Re: Cavalo Ranch MDP # 764

The City Staff Development Review Committee has reviewed Cavalo Ranch Master Development Plan M.D.P. # 764. Please find enclosed a signed copy for your files. Your plan was accepted, however please note the following:

CAVALO RANCH PRELIMINARY OVERALL DEVELOPMENT PLAN AMENDMENT

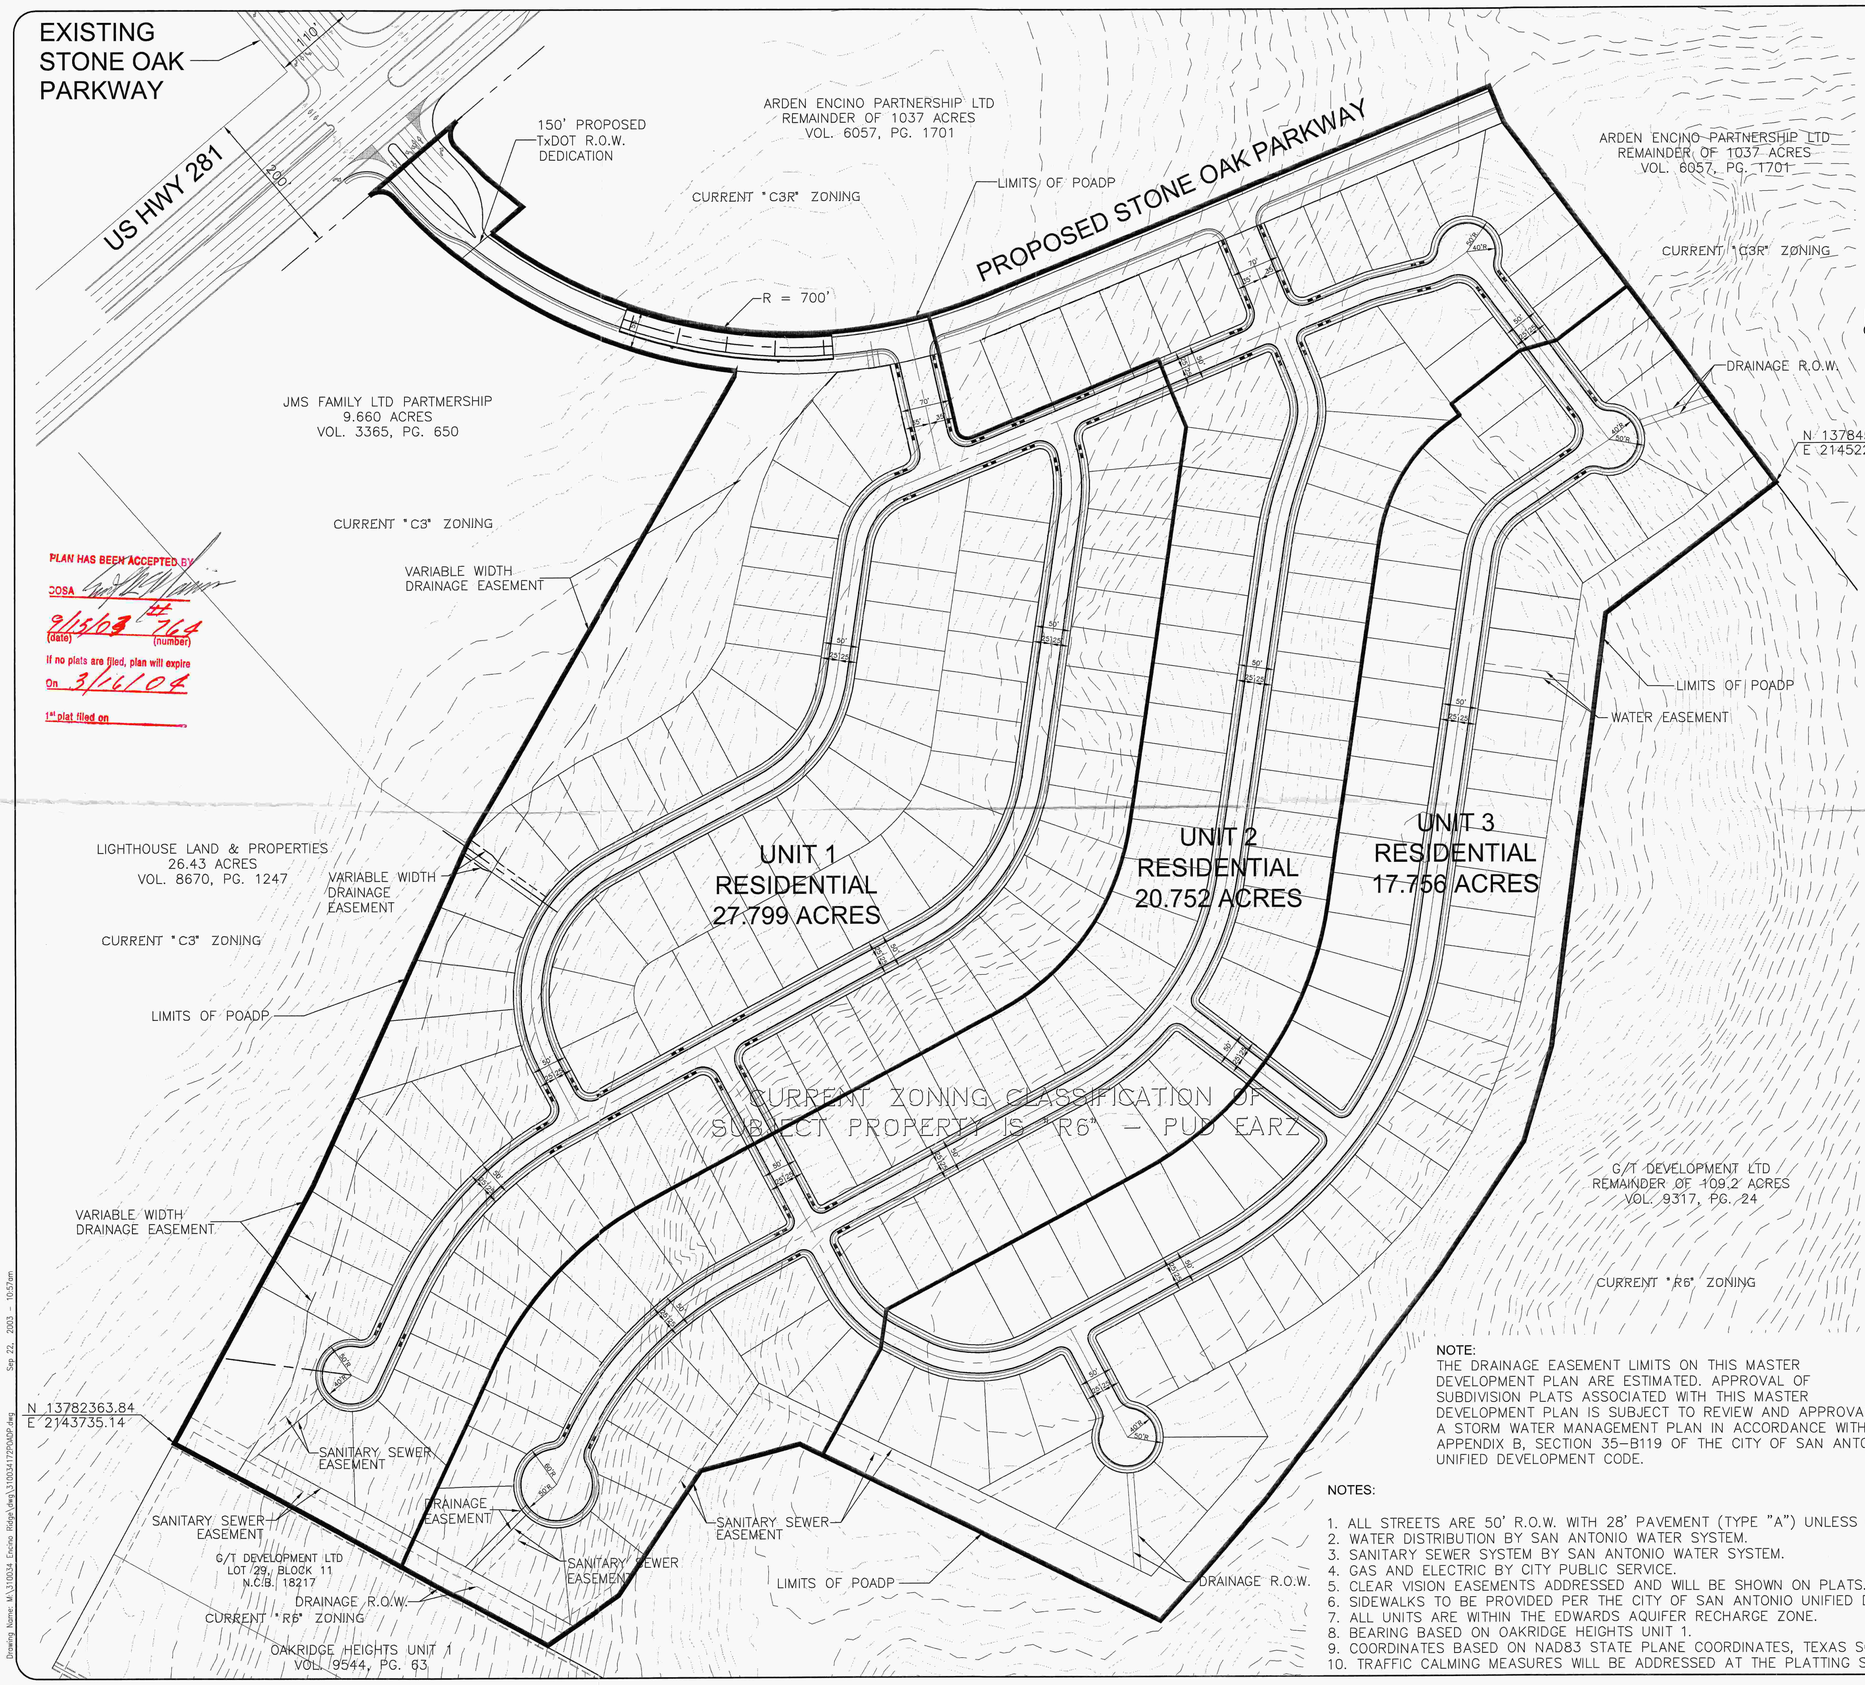
- In consideration of public safety and convenience, excessive grades by reason of topography should be avoided in street layouts and arrangements.

1. Streets longer than 1200' must have traffic calming (preferably islands) as per the unified development Code (UDC), Section 35-506(d)(6)Cul-de-sacs greater than 500' require 30' pavement and 120' ROW in Diameter.

2. Cul-de-sacs and Knuckles shall be label with the appropriate Radii.

- It will be expected that you will plat all of the property depicted in your Master Development Plan (M.D.P.) to include floodplains, drainage areas and open space.
